AURIX™ TC37x errata sheet

Marking/Step: (E)ES-AA, AA

About this document

Figure 1 Message buffer transfer from Message RAM to OBF

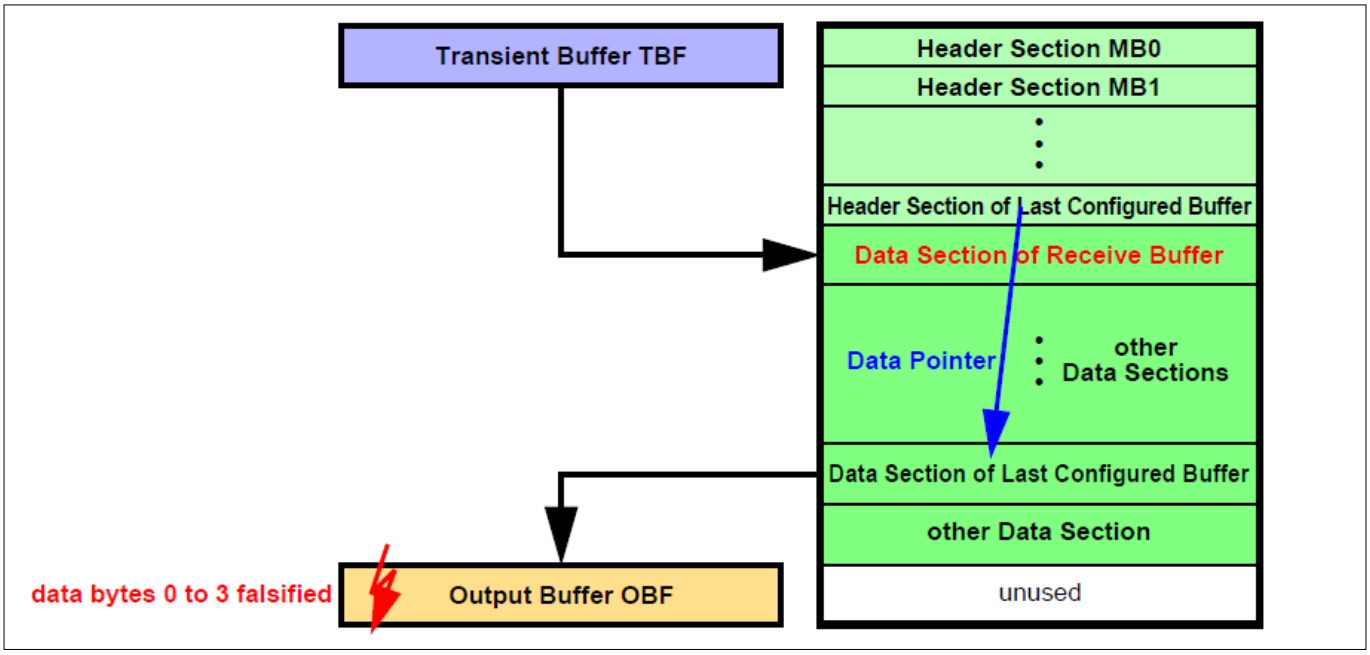
When the message buffer has its payload configured to maximum length (PLC = 127), the OBF word on address 00h (payload data bytes 0 to 3) is overwritten with unexpected data at the end of the transfer.

a) When a message is transferred from the Last Configured Buffer in the Message RAM to the OBF and PLC = 127 it may happen, that at the end of the transfer the OBF word on address 00h (payload data bytes 0 to 3) is overwritten with unexpected data (see Figure 1)

Figure 2 Message buffer transfer from IBF to Message RAM

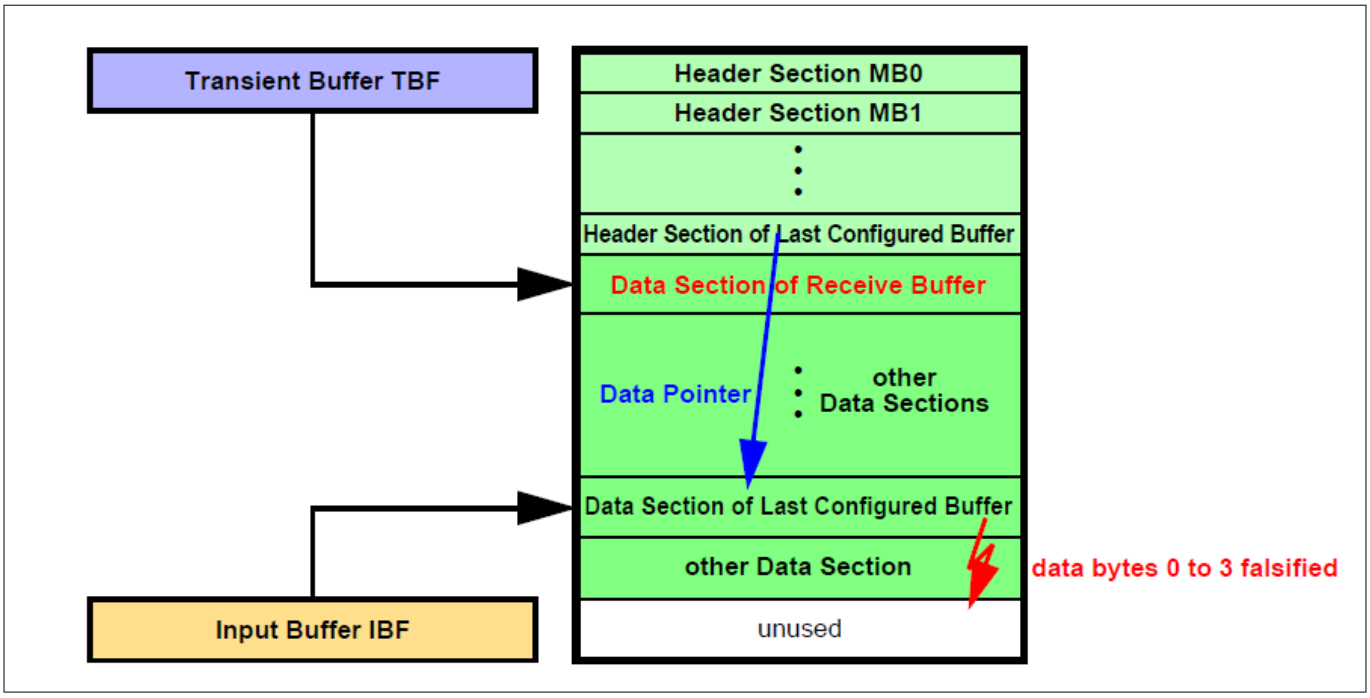
After the Data Section of the selected message buffer in the Message RAM has been written, one additional write access overwrites the following word in the Message RAM which might be the first word of the next Data Section.

b) When a message is transferred from IBF to the Last Configured Buffer in the Message RAM, it may happen, that at the end of the transfer of the Data Section one additional write access overwrites the following word, which may be the first word of another message's Data Section in the Message RAM (see Figure 2)

Figure 3 Message RAM configurations

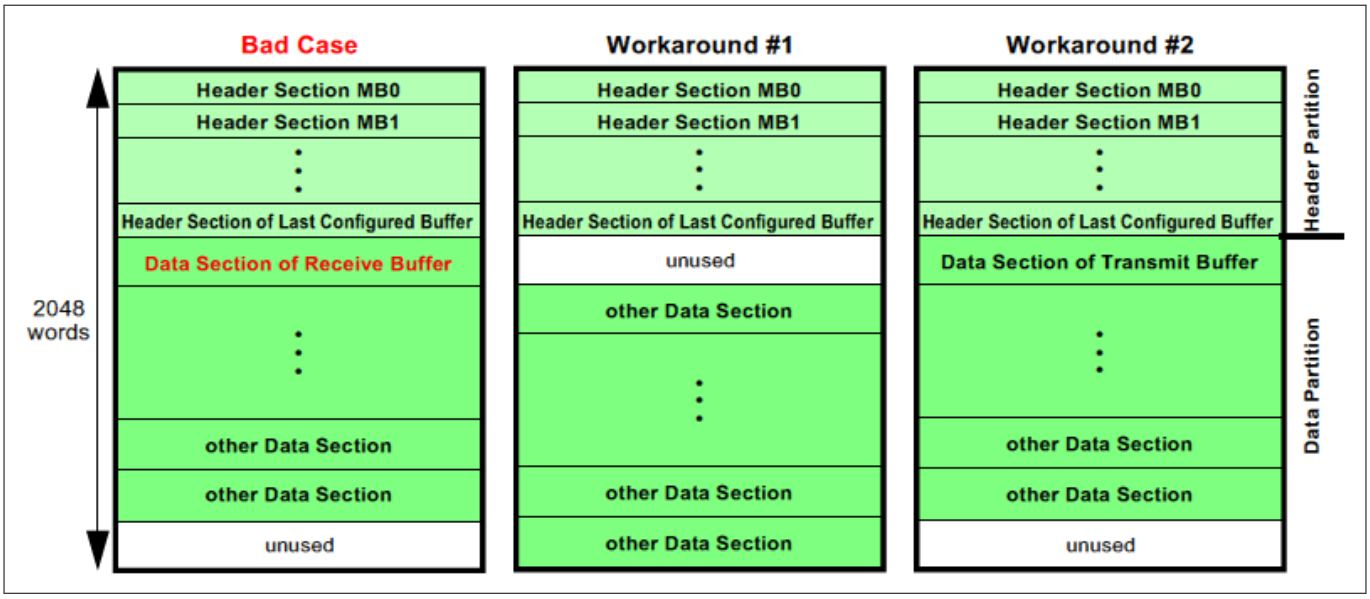
The erratum is limited to the case when (see Figure 3 “Bad Case”):

Ensure that the Data Section directly following the Header Partition is assigned to a transmit buffer.

Figure 6 Critical MCS AEI master scenario

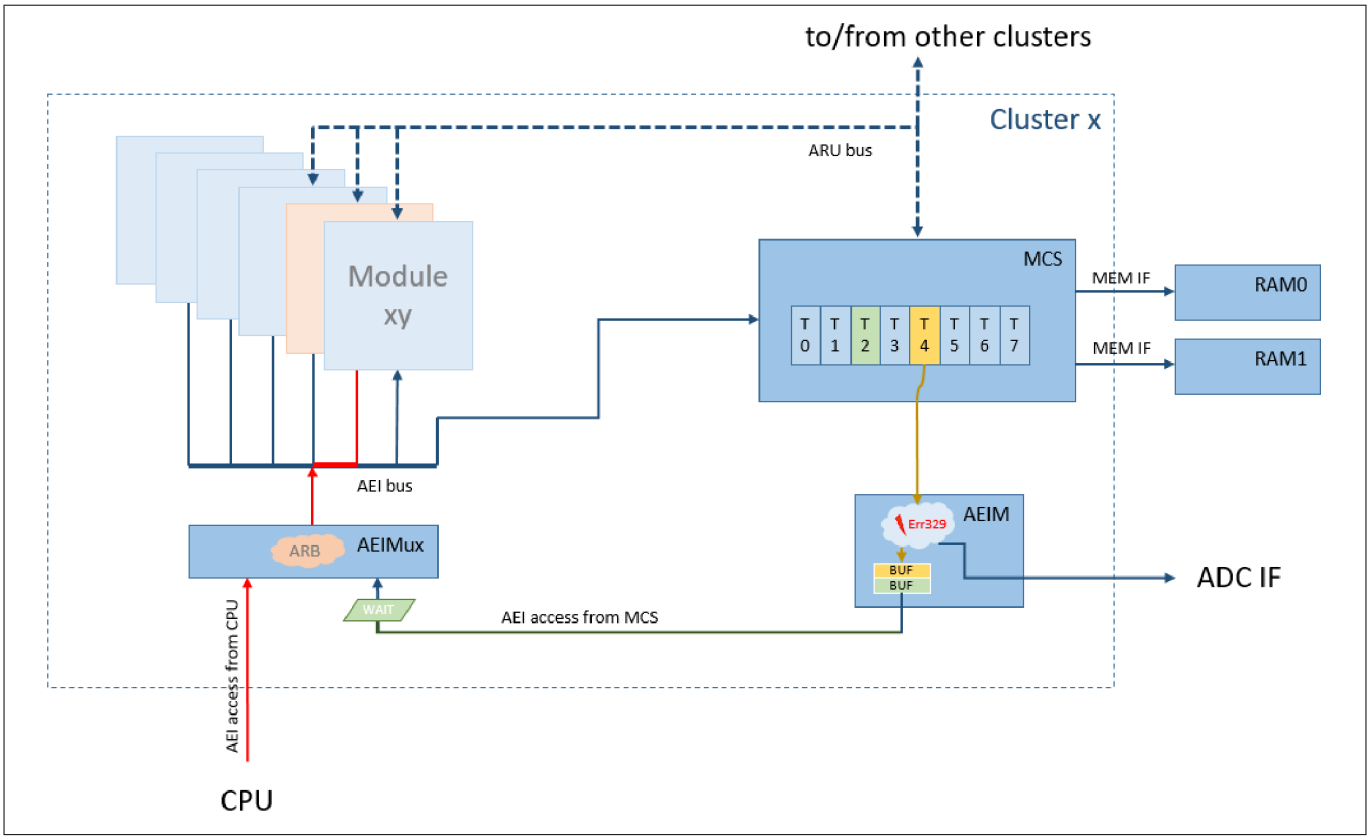
In Figure 6, a potential risk for the occurrence of problem GTM_AI.329 is illustrated. Here the first buffer of the AEIM (green) is still waiting for the access to the AEI bus while a second AEI bus access from MCS arrives at the AEIM (yellow access path). Under certain, but for the user unpredictable timing conditions, this second AEI bus access arriving at the AEIM can trigger the misbehavior described in problem GTM_AI.329.

The workarounds described in the 'Workaround' section will ensure that not more than one AEIM buffer will be filled and therefore the occurrence of problem GTM_AI.329 is avoided. All workarounds have been tested and proven correct.

Figure 7 MCS token mechanism

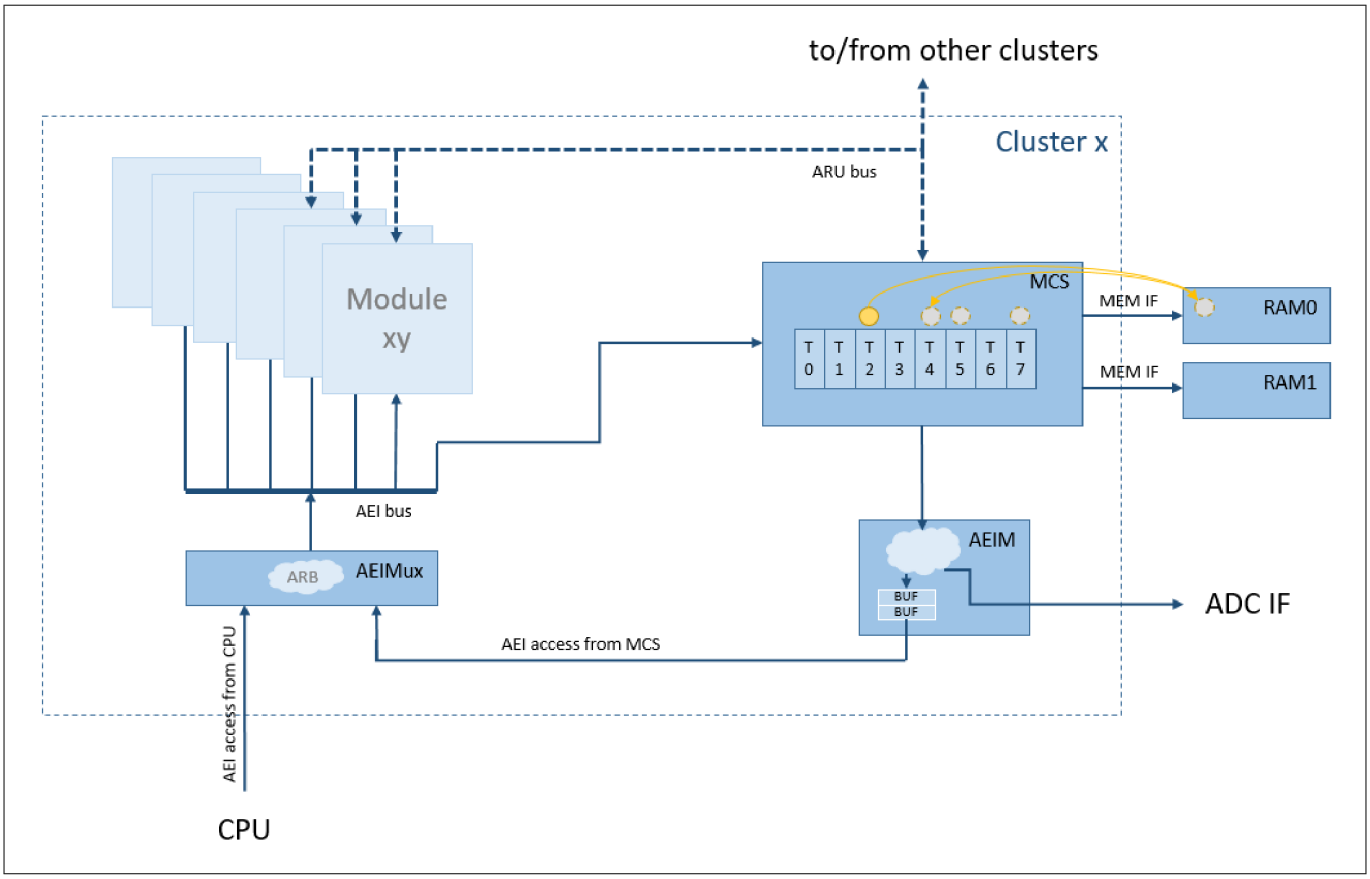
In case multiple MCS channels want to use the AEI master port for AEI or ADC communication, establish a mechanism that ensures that only one channel uses the AEI master at a time (e.g. exchange a token between channels or use trigger registers to hand over the AEI master port ownership between MCS channels).

An application note (AN020 – MCS Mutex implementation) describing a token exchange mechanism between MCS threads is available at Bosch. Such a token mechanism allows multiple MCS threads to safely access the AEI bus system by exchanging an AEI bus access token via MCS memory.

Figure 8 TBU value evaluation MCS against other modules. Red (past) and green (future).

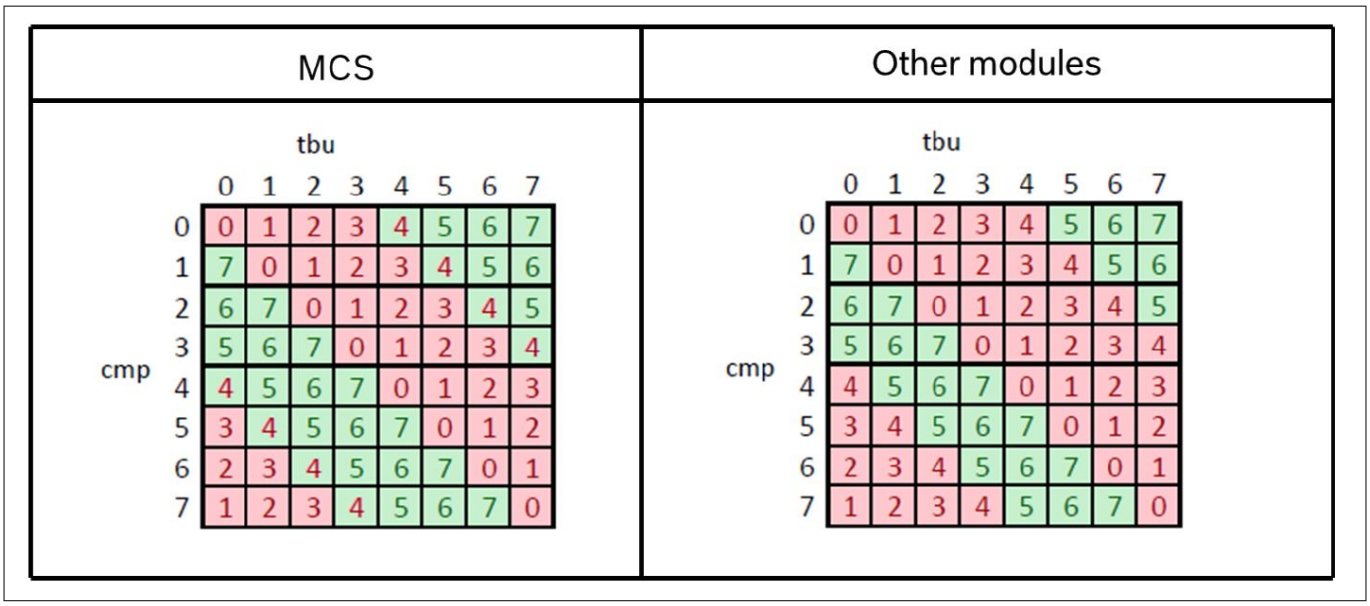
The GTM specification for the Cyclic Event Compare was not detailed enough to describe the complete range including the boundaries between future and past.

With the revised specification of GTM 4.1 it was revealed that the implementation for the WUCE instruction is not correct for the boundaries. The implementation of the WUCE instruction has an inverted behavior for both boundaries between future and past.

Figure 10 CAN Frame with DLC > 4

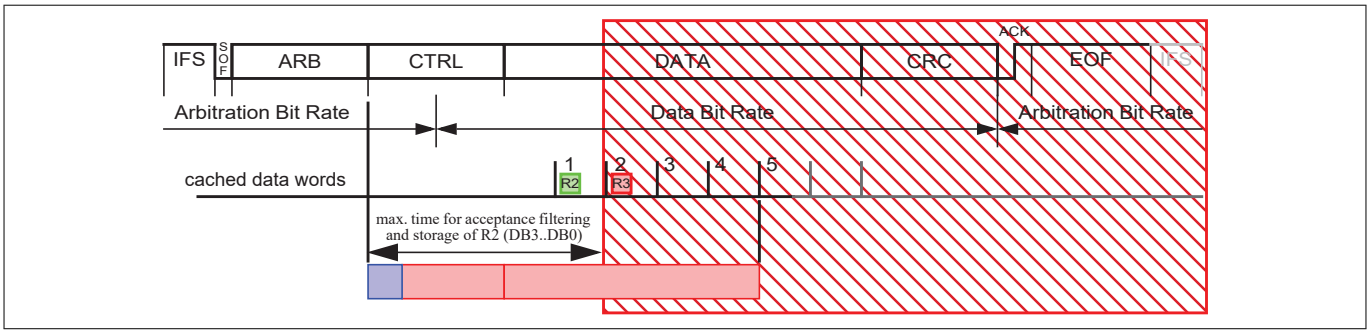
The figure that follows shows how the available time for acceptance filtering and storage is reduced.

Figure 11 Interrupt Level vs. Pulse-Notify mode - Corner Case Example

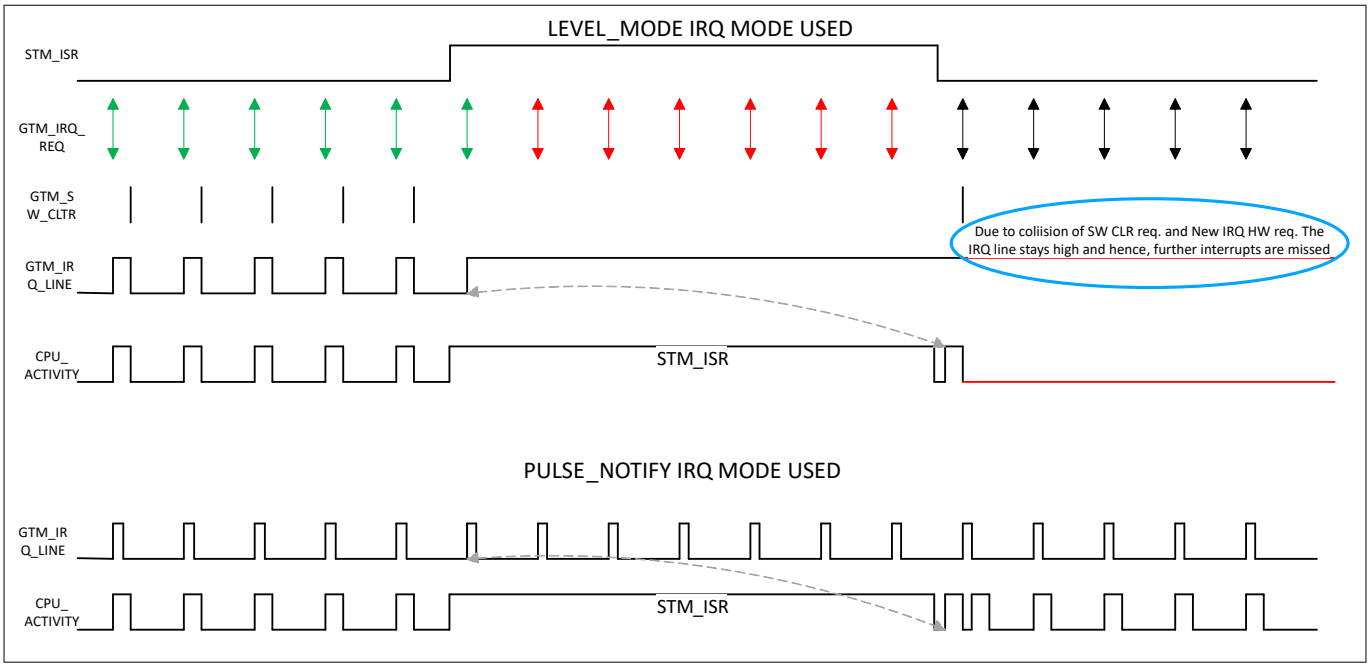
Hence, in Level Mode, in some scenarios where another interrupt request is generated by GTM while the ISR handle also requests a SW clear, then, as the interrupt event is dominant over the clear event (for simultaneous

interrupt and clear events), GTM_IRQ_XXX is not cleared and remains high. As a consequence, the IR observes no transition on GTM_IRQ_XX. Thus, any forthcoming interrupt events in this scenario are lost as there is no chance to release the CPU IRQ when a collision happens as shown in Figure below.

If Pulse-Notify mode is selected, every internal trigger will be forwarded to the IR, irrespective of the time of occurrence and the clear event, as the pulse-notify leads to set and reset of GTM_IRQ_XXX as compared to only setting of the GTM_IRQ_XXX line in Level mode.

Figure 12 Timing of LVDS TX interface command sending in relation to IRQ.IFCFS

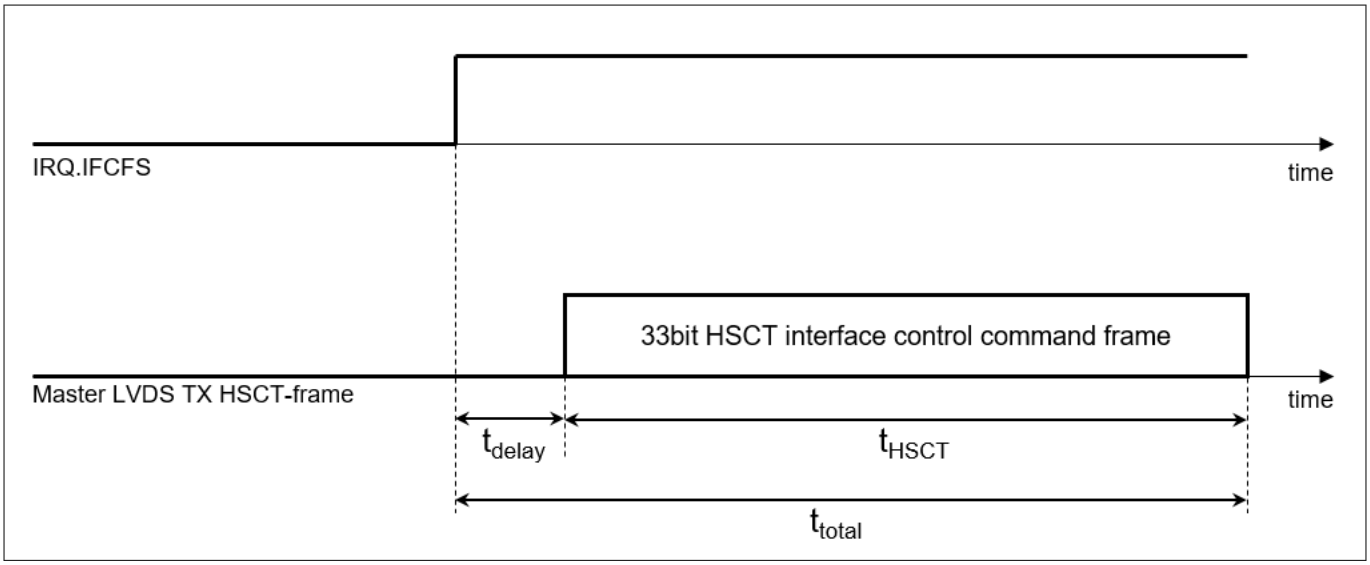
the user might falsely assume that also the actual sending on the LVDS TX port has already occurred once the IRQ.IFCFS flag is set, which is not true.

Instead the timing shown in the following figure applies.

Figure 13 Package Outlines LQFP-176 for TC37x

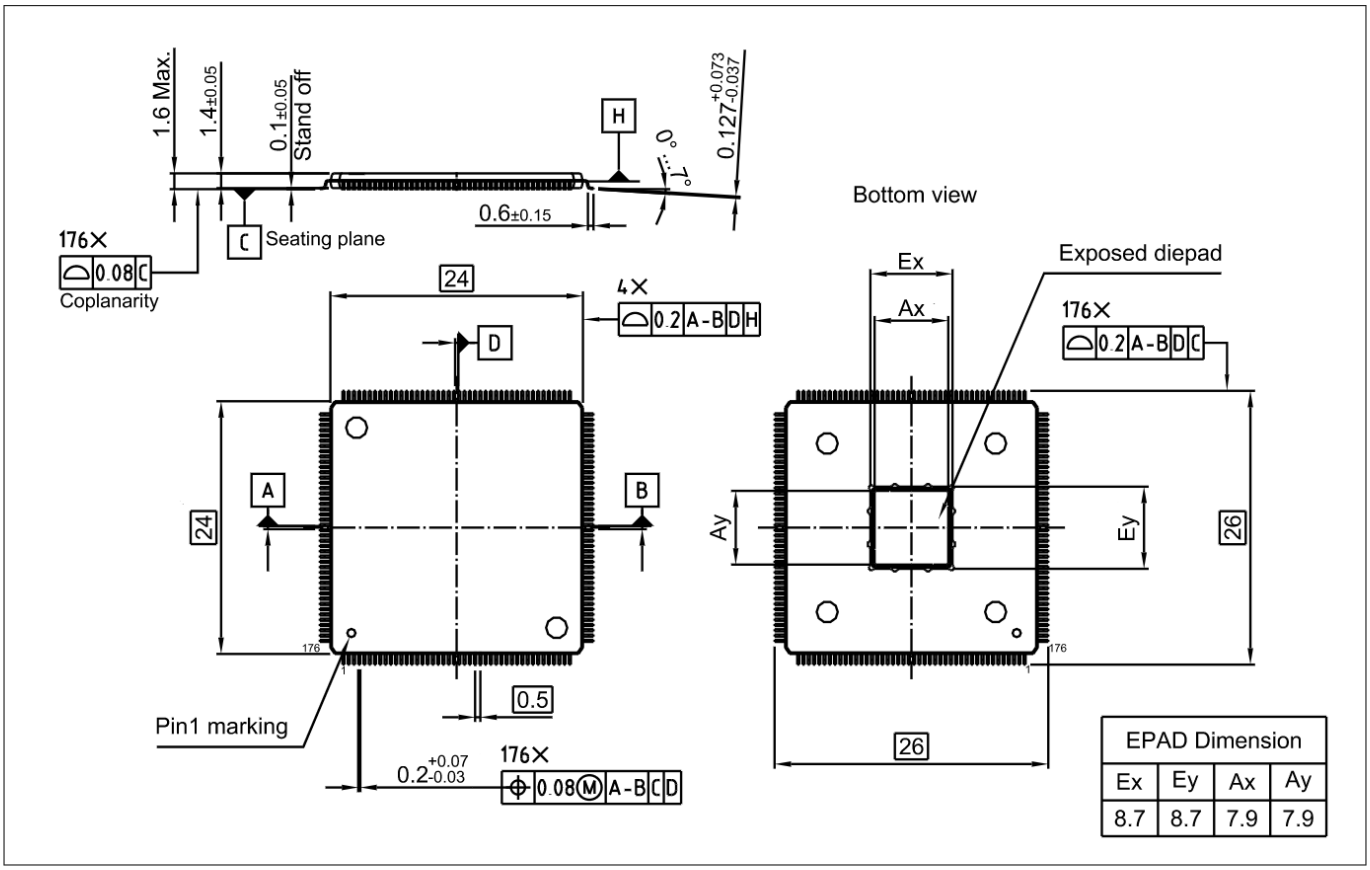
Furthermore, for the exposed die pad, the maximum boundary of the structural corner protrusions to be considered during system design and integration has been added.

This information shall substitute the corresponding information in the TC37x AA-step Data Sheet V1.1.

***Note**: For the exposed diepad of the LQFP-176 package of the TC37x, structural corner protrusions have to be considered for purposes of system design and integration with a maximum boundary of 9.4 mm.*
